Recall Campaign 04V-182: Fuel Pump Resistor Retrofit

All E85 Z4 vehicles produced from February 2003 through October 2003.

Recall Campaign No. 04V-182: Engine Stalling

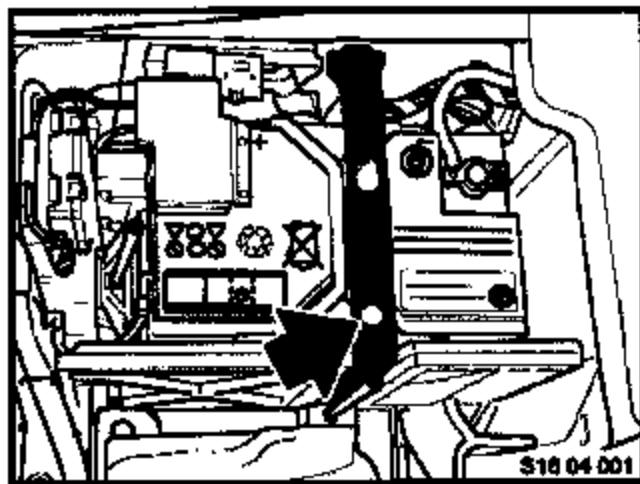
Install a resistor in the ground side of the fuel pump circuit to limit pump speed.

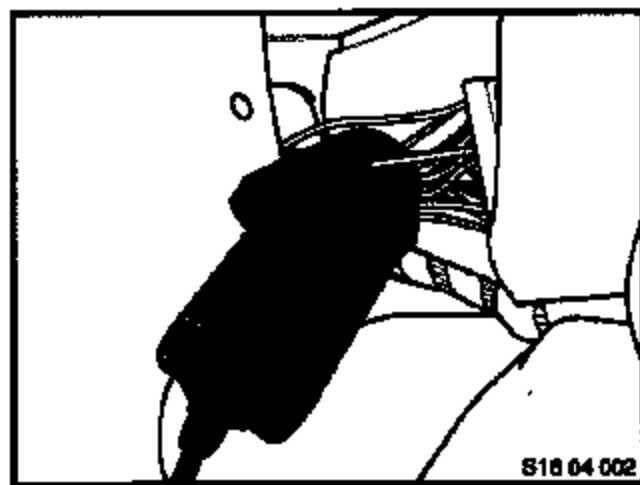
Remove luggage compartment floor to expose the battery. If there is a white sticker on the battery holder (see illustration), no further action is necessary. If there is no sticker, proceed with resistor installation.

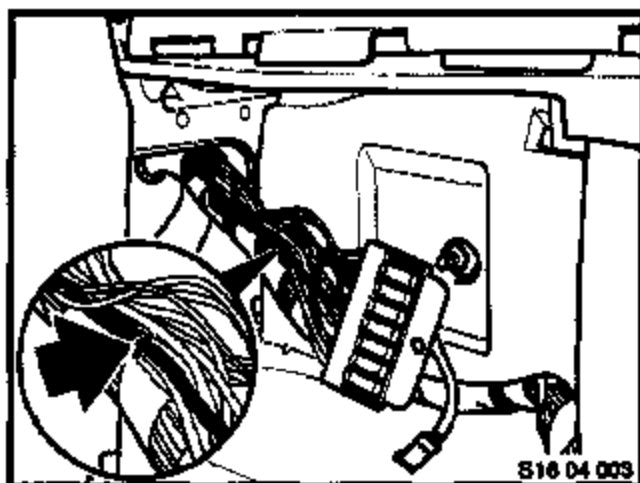
Disconnect the battery and unbolt the comb connector from the body.

Cut the fuel pump ground wire about 5cm from the comb connector. Strip both

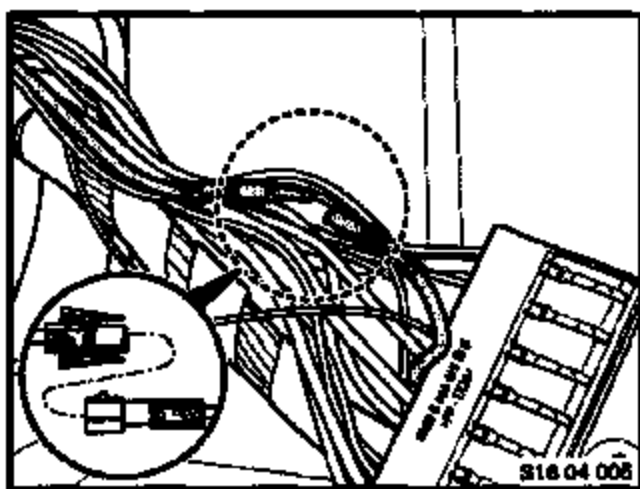
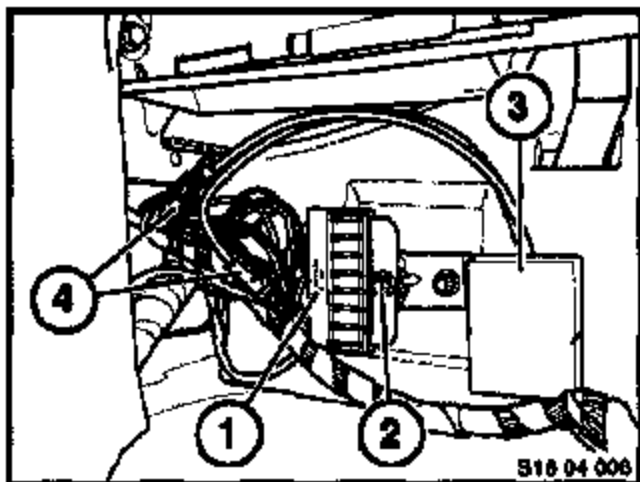
Crimp the pin contact to the vehicle side of the wire and the socket contact on the wire to the comb connector. Lock these connectors within their respective insulator.

Place the resistor (3) on the comb connector mounting stud first, followed by the comb connector (1). Reinstall the nut and tighten (2). Connect the resistor leads to the lead from the comb connector and the one to the vehicle harness. Secure the cables with a tie wrap. Reconnect the battery and start the engine. If everything checks out, reassemble the luggage compartment.
